SUNDRY NOTICES AND REPORTS ON WELLS
*Do not use this form for proposals to drill or to re-enter an
abandoned well. Use form 3160-3 (APD) for such proposals.*

Because of, Cimarex has decided to move the High Lonesome 23 Federal No. 1 well as shown below:

Revised Drilling Plan
High Lonesome 23 Federal No. 1
 Cimarex Energy Co. of Colorado
 23-16S-29E
 SHL 2310 FNL & 660 FEL
 BHL 2310 FNL & 330 FWL
 Eddy County, NM

PECOS DISTRICT CONDITIONS OF APPROVAL

WELL LOCATION AND ACREAGE DEDICATION PLAT

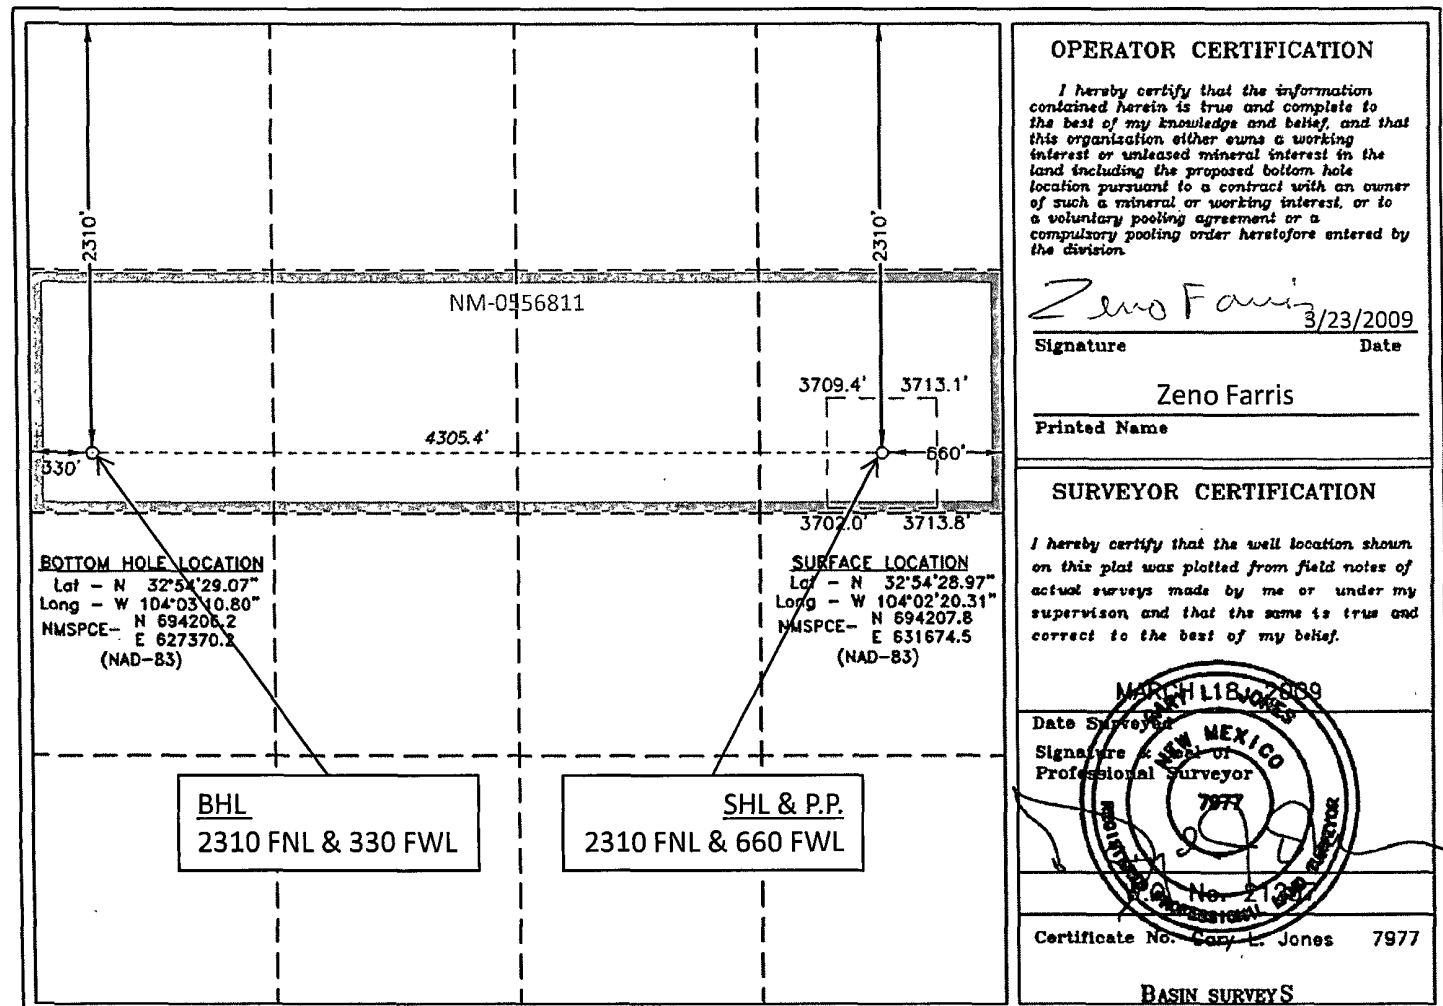
Permitted Location

23-16S-29E
SHL 1980 FNL & 330 FWL
BHL 1980 FNL & 330 FEL

New Proposed Location

23-16S-29E
SHL 2310 FNL & 660 FEL
BHL 2310 FNL & 330 FWL

Rig Diagram
High Lonesome 23 Federal No. 1
 Cimarex Energy Co. of Colorado
 23-16S-29E
 SHL 2310 FNL & 660 FEL
 BHL 2310 FNL & 330 FWL
 Eddy County, NM

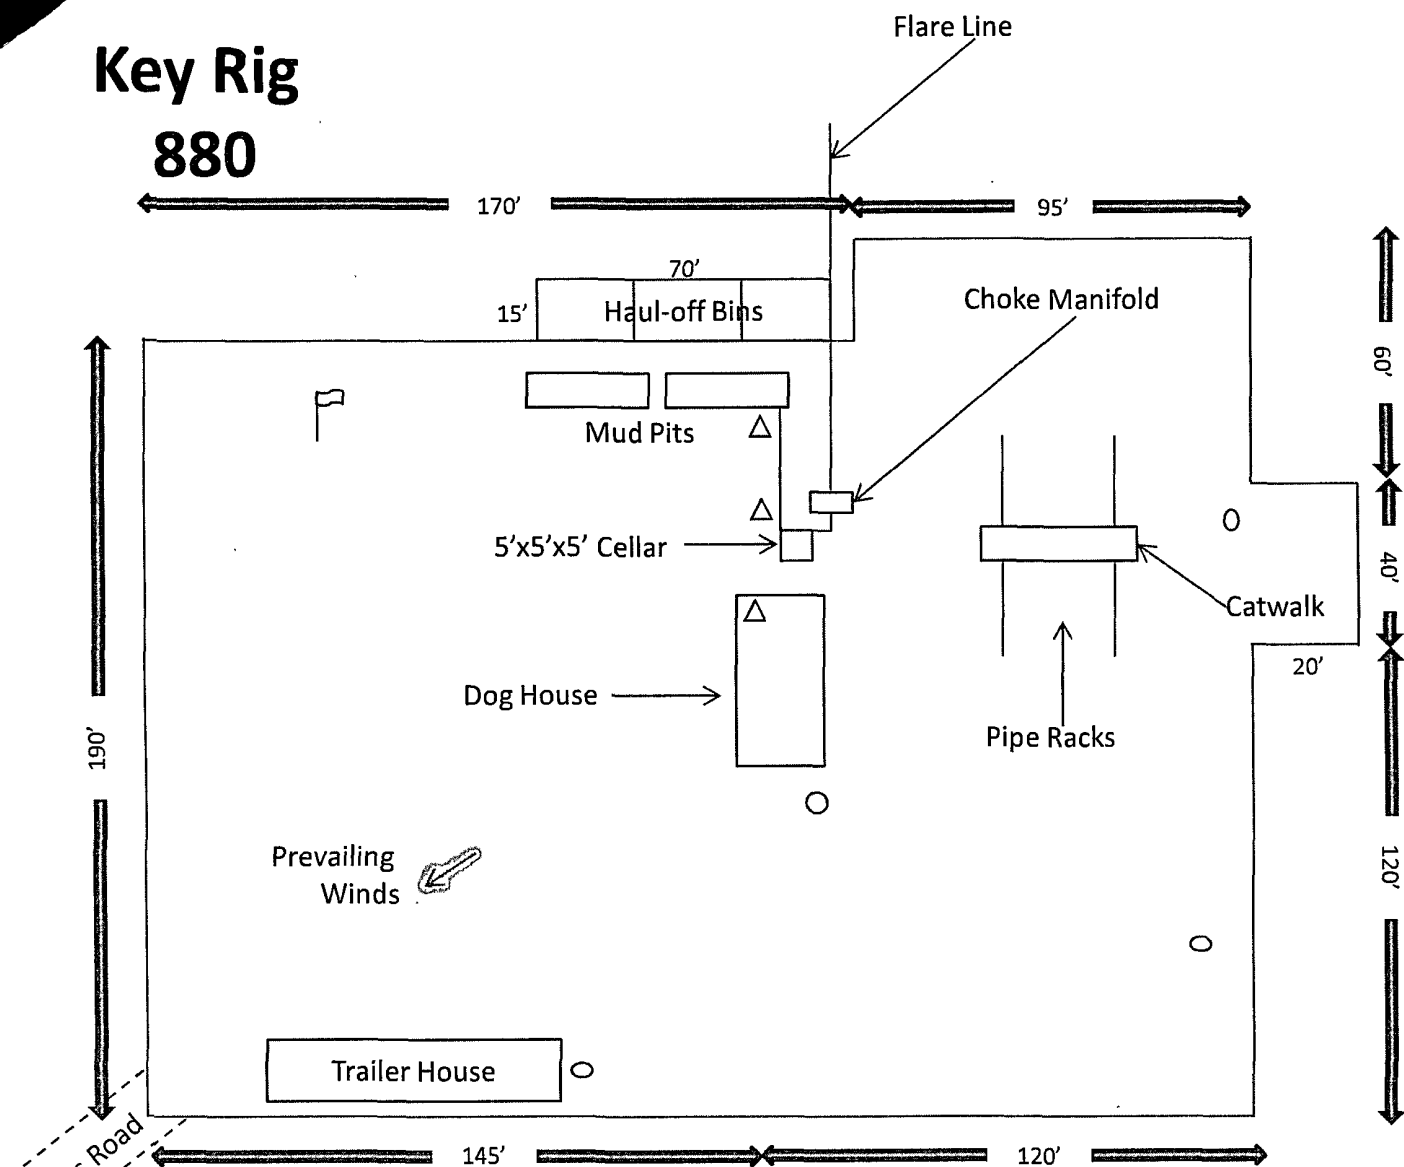
Please see attached revised drilling plans, plats, and preliminary directional survey. We are also switching to a haul-off bin system as shown on the attached revised rig plat. MOA application is in progress in lieu of an archaeological report. A Federal ROW application is in progress for the proposed acces road.

Closed Loop System V- Door South

Tanks are required for drilling operations: No Pits.

Figure 1 - Cross Sections and Plans For Typical Road Sections

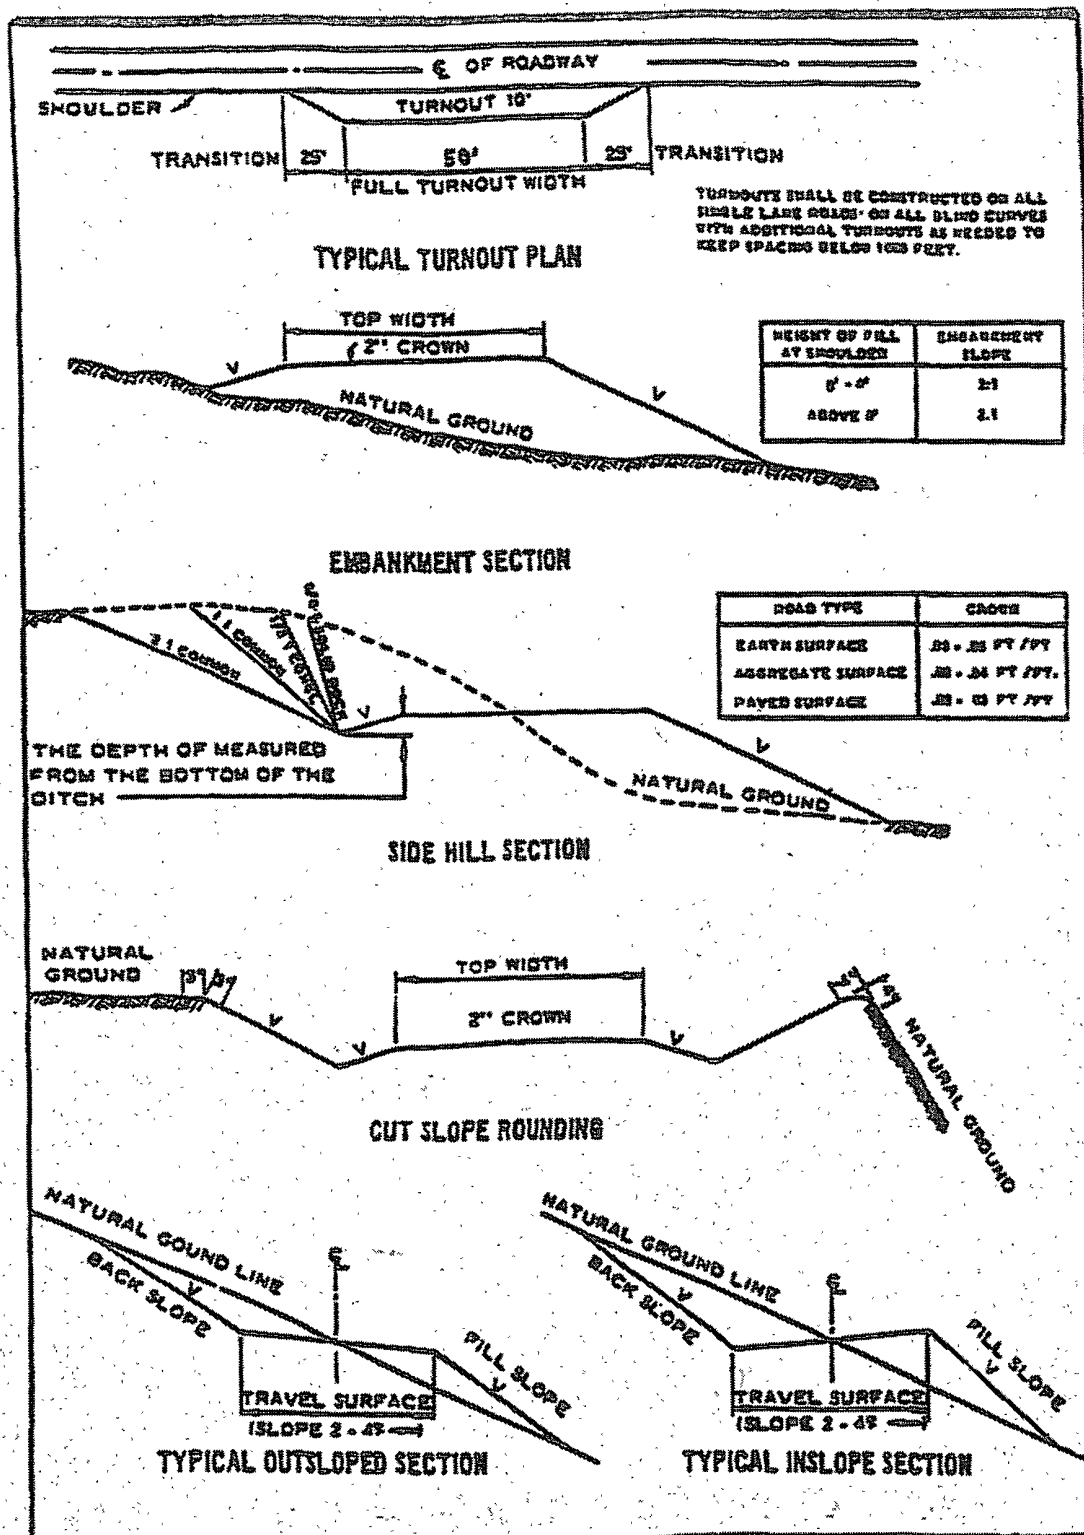
Crowning shall be done on the access road driving surface. The road crown shall have a grade of approximately 2% (i.e., a 1" crown on a 14' wide road). The road shall conform to Figure 1; cross section and plans for typical road construction.
